### Remarks

Appl. No. 09/956,954  
Amdt. dated October 20, 2004  
Reply to Office Action of July 13, 2004

FIG. 12

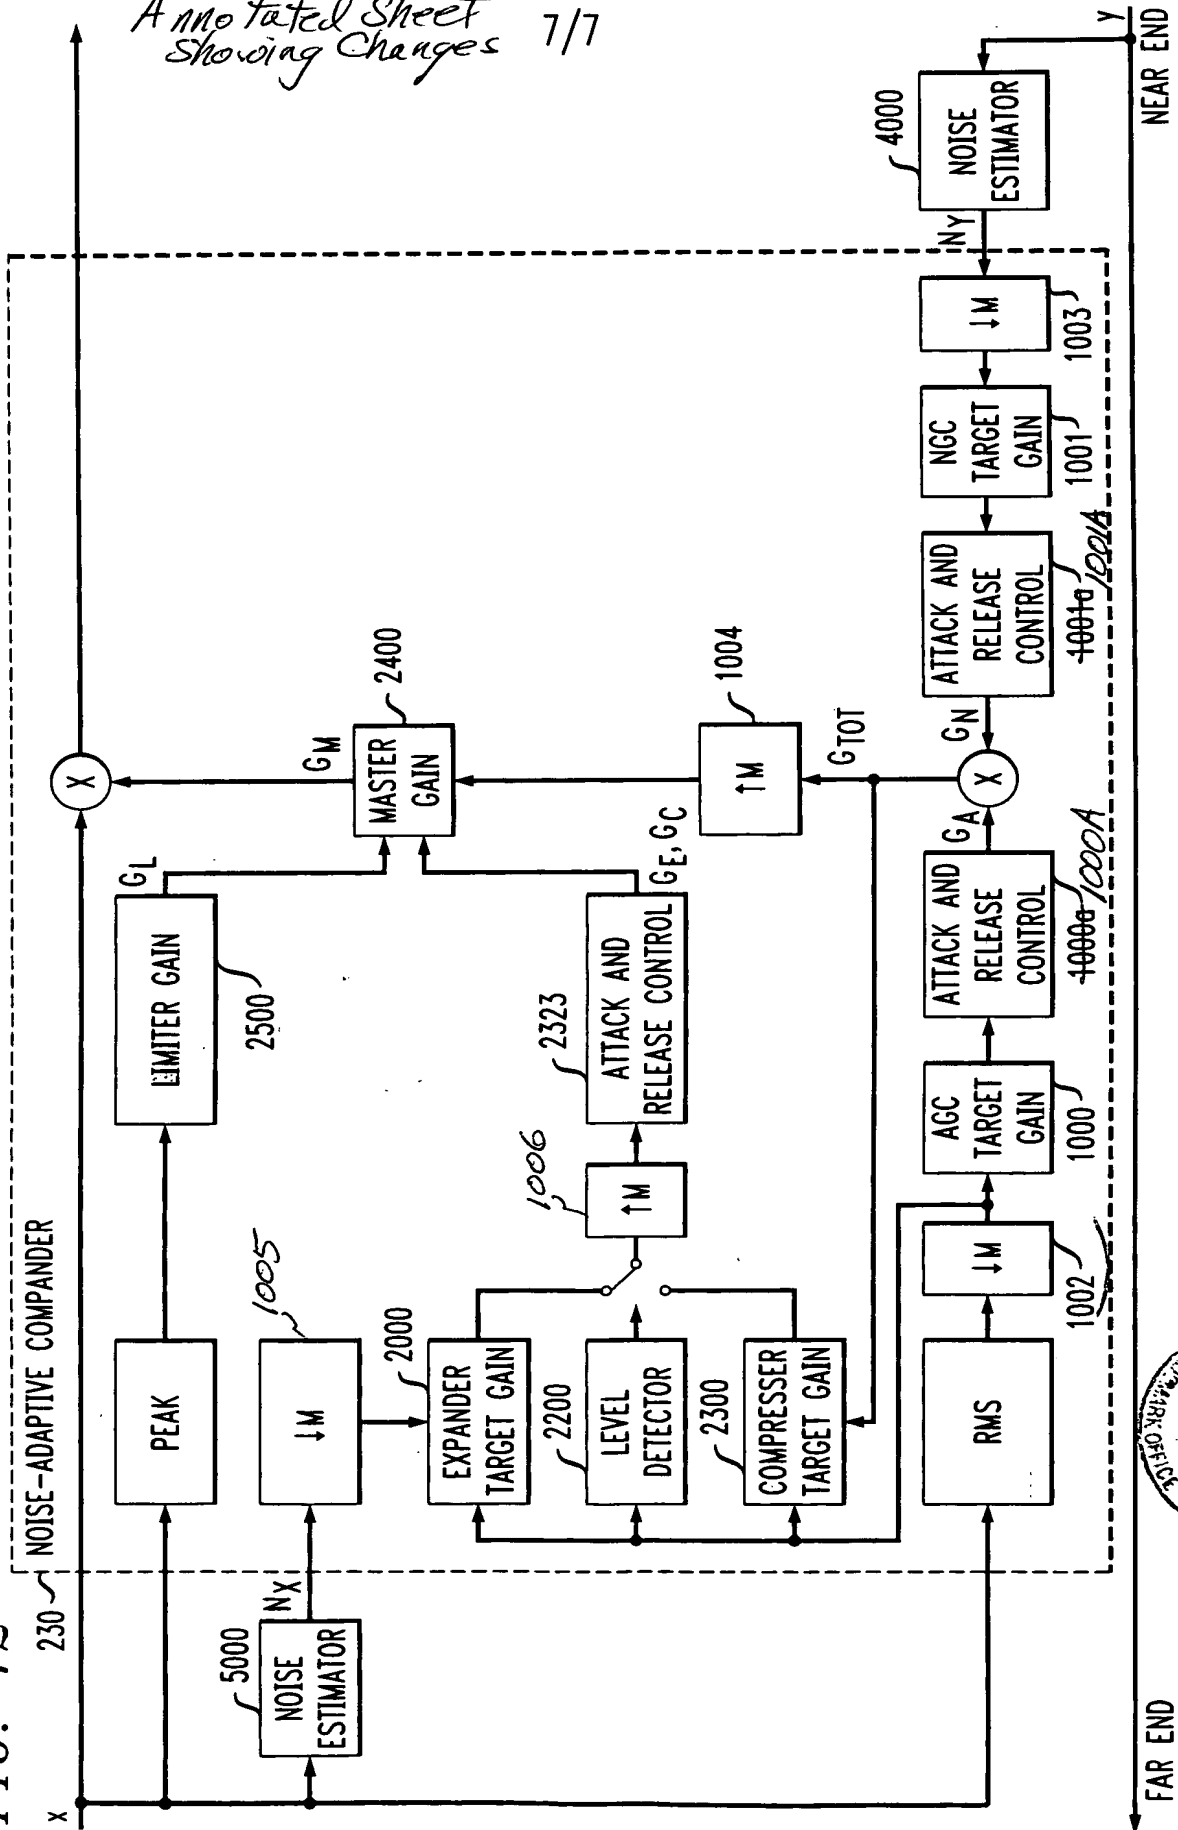
Paragraph [0073] is amended to correct typographical errors in referencing units in Fig. 12. Fig. 12 illustrates unit 2200 as a level detector and unit 2000 as an expander. Reference to unit 2200 as an expander is amended to correctly reference the unit 2000 as the expander in two places in paragraph [0073]. In the first location to be changed, the second sentence of paragraph [0073] is amended: "For example, compander 230 comprises both near- and far-end noise estimators 4000,5000, and AGC gain unit 1000, and NGC gain unit 1001, expander, compressor and limiter gain units ~~2200~~2000,2300,2500 along with a master gain unit 2400." In the second location to be changed, the sixth sentence of paragraph [0073] is amended to read: "For one thing, attack and release control unit 2323 is associated with both the expander and compressor gain units ~~2200~~2000, 2300." Also, it was inadvertently stated that "...units 100, 101, 200-500 shown in FIG. 3 also comprise attack and release control units..." Master gain unit 400 should not have been included in this group since the corresponding master gain unit 2400 of Fig. 12 does not illustrate the use of an attack and release control. This inadvertent error is corrected by amending the text to read "...units 100, 101, 200, 300, and 500 shown in FIG. 3 also comprise attack and release control units..." Also, Fig. 3 illustrates unit 200 as an expander. The seventh sentence of paragraph [0073] is amended to properly reference the expander as unit 200: "As envisioned by the present invention, the compander 23 shown in Fig. 3 would necessarily use separate attack and release control units for each of the expander and compressor gain units 200,300,500."

FIG. 10

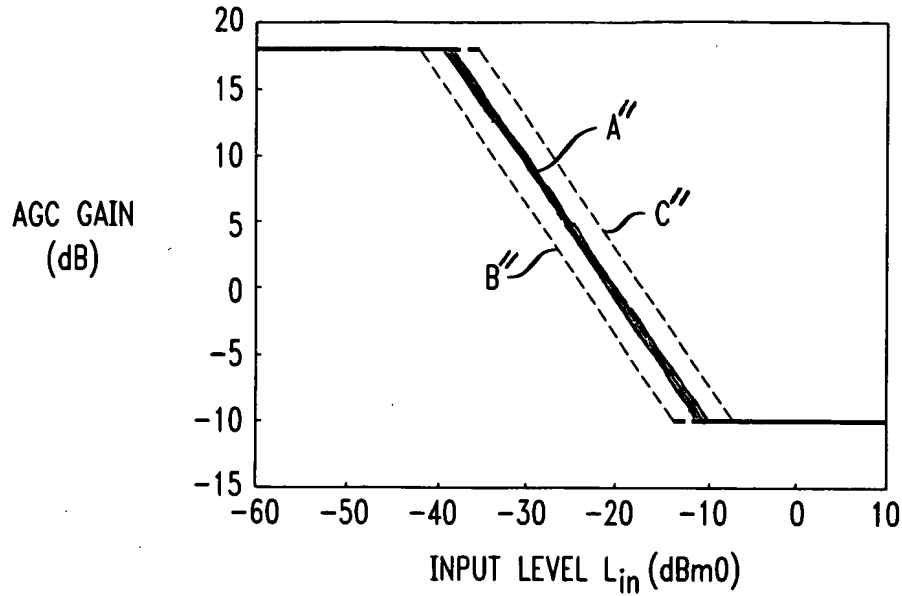
In paragraph [0069], the curves labeled A, B, and C of the last sentence of paragraph [0069] have been relabeled A", B", and C" to differentiate the curves of Fig. 10 from the curves labeled A, B, and C of Fig. 4.

FIG. 7

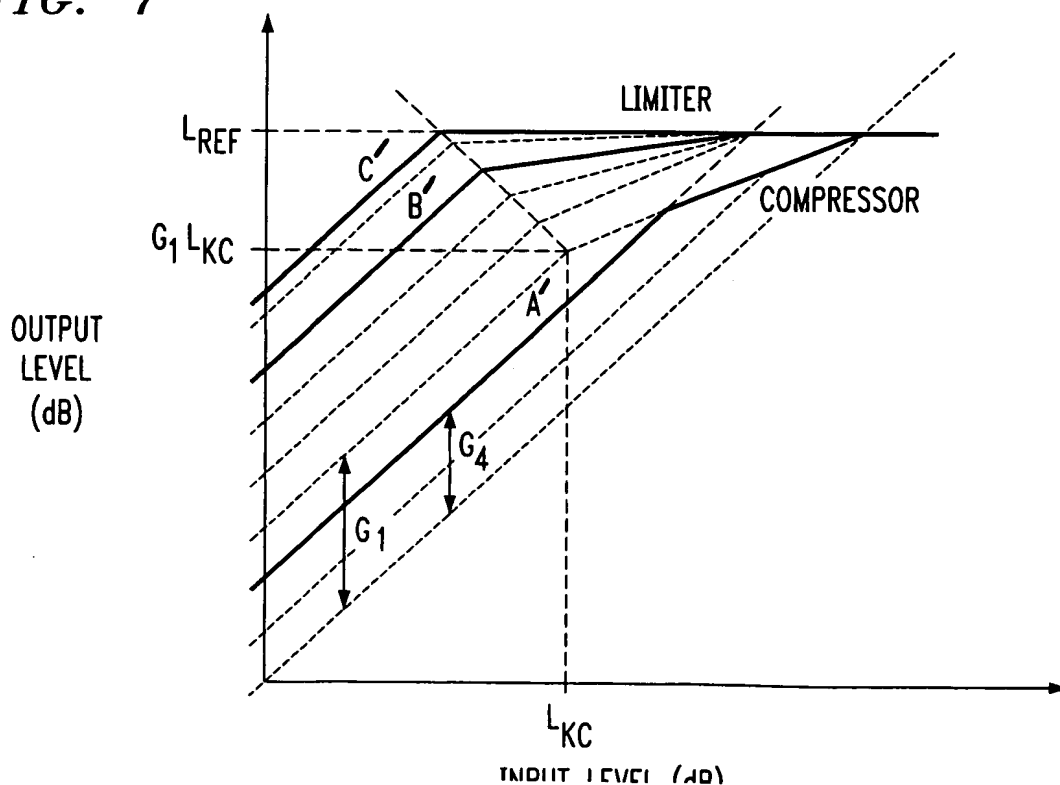
Paragraph [0053] is amended to identify the curves of Fig. 7 as curves A', B', and C'.
